TMS320C6203, TMS320C6203B
Digital Signal Processors
Silicon Errata

C6203B Silicon Revisions 2.x, 3.0, 3.1

SPRZ174L
November 2000
Revised February 2004

Figure 3. Failing Transfer as Seen at Destination

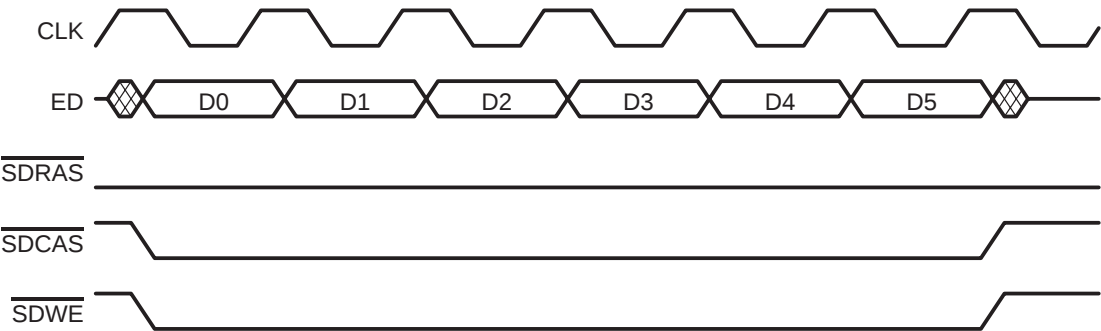
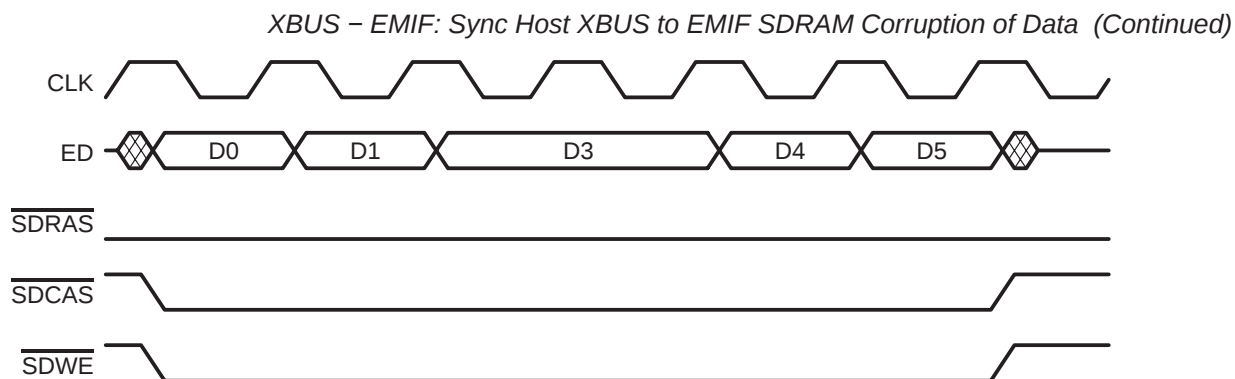
Details: When performing an XBUS Synchronous Host Master Read, corruption of data may occur in some cases where an XBUS wait occurs concurrently with a not-ready input. One word may be overwritten by a subsequent word, corrupting the data. An example of a transfer as it was intended is shown in Figure 2. Figure 3 shows an example of how the data might be corrupted with D3 overwriting D2.

- Do not stall the XRDY signal during the cycle when there is an XWAIT asserted.
- This frequency may be alleviated by increasing the CPU CLK:CLK frequency ratio past 10:1.

Figure 5. Incorrect Transfer via the Synchronous Host Port Mode of the Expansion Bus.

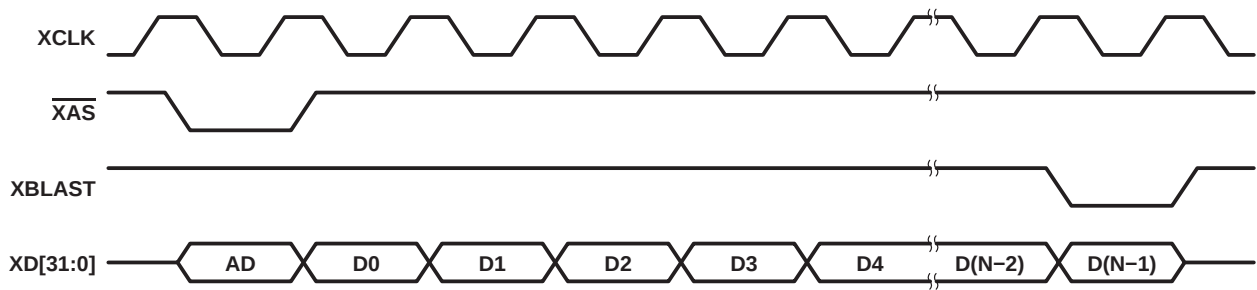
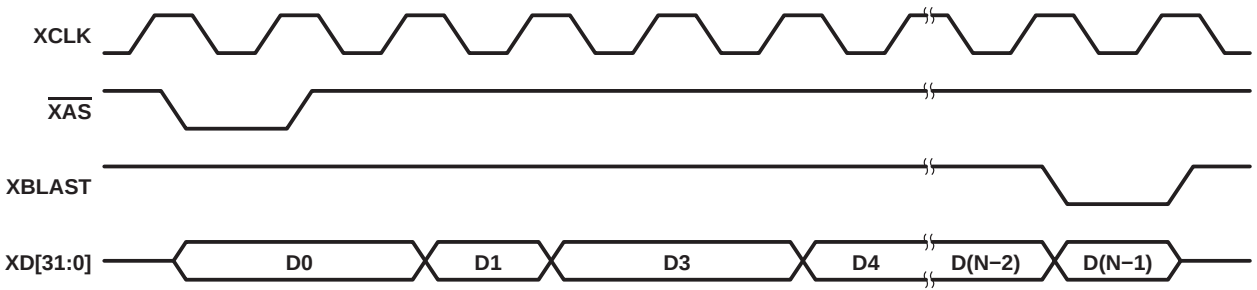
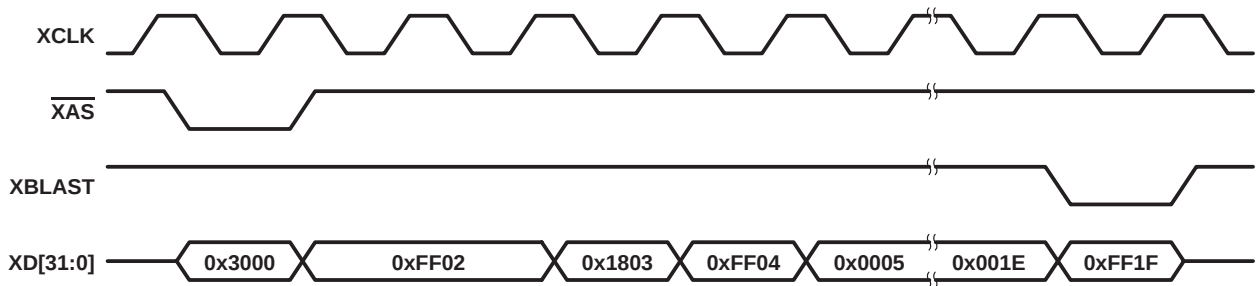
Details: While the expansion bus is operating in Synchronous Host Port Mode, certain expansion Bus output signals may be corrupted. The corruption occurs on output signals only and there are no known issues with any other XBUS modes (Asynchronous Host Mode, Asynchronous I/O Mode, or Synchronous FIFO Mode). In Synchronous Host Port Mode, some or all outputs of the XD signal lines move from the next word into the current word being transferred. This corruption not only affects the XD signal lines, but the output control signals as well (XAS, XBLAST, etc.). Figure 4 shows what a typical Synchronous Host transfer should look like. Figure 5 shows the address (AD), as well as data word 2 (D2) being corrupted by the next word. In this figure, the address is corrupted by D0 and D2 is written over by D3. Figure 6 is an example showing D0 being completely corrupted by D1 and D3 being partially corrupted by D4. The transfer should be 0x0001, 0xFF02, 0x0003, ..., 0xFF1F to Address 0x8000.

Workaround: The best method of reducing the number of failures resulting from this issue is to increase the voltage and decrease the CPU Clock speed. For Rev. 2.1 and earlier revisions, 1.5-V / 300-MHz devices should operate correctly at 1.7 V / 250 MHz. This issue will be fixed in the next major revision.

XBUS: FIFO Data and Control Signals Zero Delay/Skewed From XFCLK High (Continued)**Figure 7. FIFO Read Timing, Glueless Read Mode****Figure 8. FIFO Read Timing**

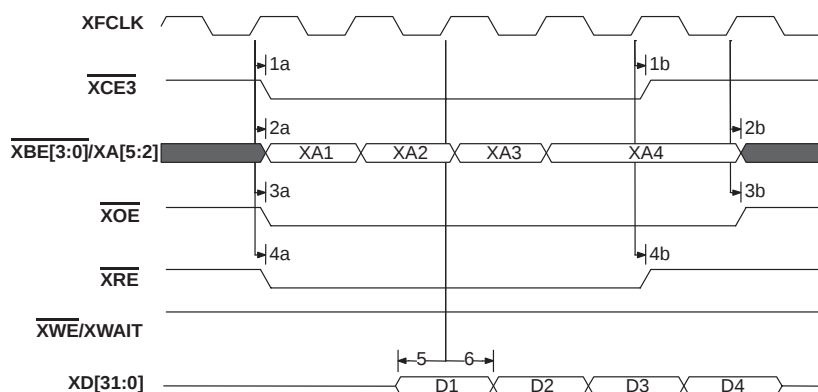
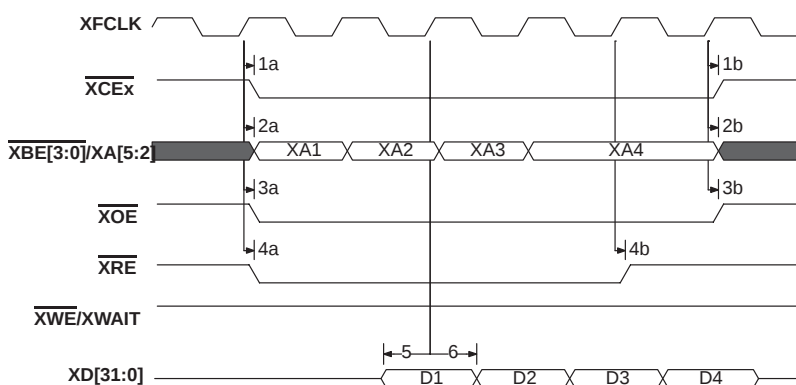
Details: In XBUS Synchronous FIFO mode, the delay time of data and control signals from XFCLK high differ from the values shown in the TMS320C6203 data sheet (literature number SPRS104A).

- $\overline{XCE}$ high-to-low transition after XFCLK high (Parameter 1a in Figure 7 and Figure 8)
- $\overline{XBE}/XA[5:2]$ valid after XFCLK high (Parameter 2a in Figure 7 and Figure 8)
- $\overline{XOE}$ high-to-low transition after XFCLK high (Parameter 3a in Figure 7 and Figure 8)
- $\overline{XRE}$ high-to-low transition after XFCLK high (Parameter 4a in Figure 7 and Figure 8)

- $\overline{XCE}$ low-to-high transition after XFCLK high (Parameter 1b in Figure 7 and Figure 8)
- $\overline{XBE}/XA[5:2]$ invalid after XFCLK high (Parameter 2b in Figure 7 and Figure 8)
- $\overline{XOE}$ low-to-high transition after XFCLK high (Parameter 3b in Figure 7 and Figure 8)
- $\overline{XRE}$ low-to-high transition after XFCLK high (Parameter 4b in Figure 7 and Figure 8)

Workaround: Do not use the glueless synchronous FIFO interface. Use external glue logic to meet the FIFO hold time requirements.

Figure 9. FIFO Write Timing

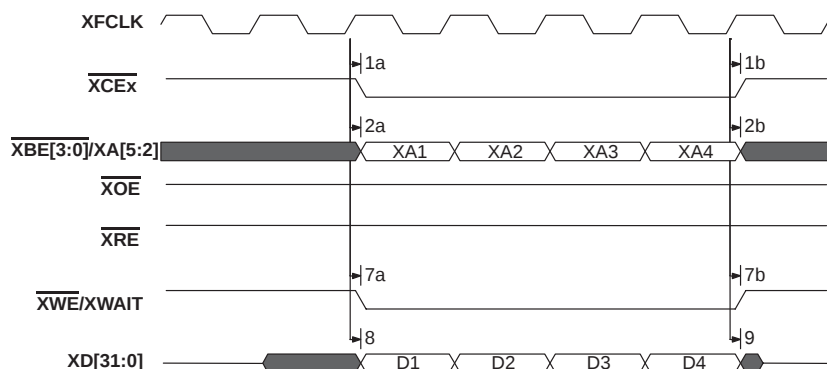
- $\overline{\text{XCE}}$ high-to-low transition after XFCLK high (Parameter 1a in Figure 9)
- $\overline{\text{XCE}}$ low-to-high transition after XFCLK high (Parameter 1b in Figure 9)
- $\overline{\text{XB}}/\text{XA}[5:2]$ valid after XFCLK high (Parameter 2a in Figure 9)
- $\overline{\text{XB}}/\text{XA}[5:2]$ invalid after XFCLK high (Parameter 2b in Figure 9)
- $\overline{\text{XWE}}$ high-to-low transition after XFCLK high (Parameter 7a in Figure 9)
- $\overline{\text{XWE}}$ low-to-high transition after XFCLK high (Parameter 7b in Figure 9)
- XD[31:0] valid after XFCLK high (Parameter 8 in Figure 9)
- XD[31:0] invalid after XFCLK high (Parameter 9 in Figure 9)

In glueless FIFO interfaces, this zero delay time may violate the hold time of the FIFO.
(Internal reference number C631252)
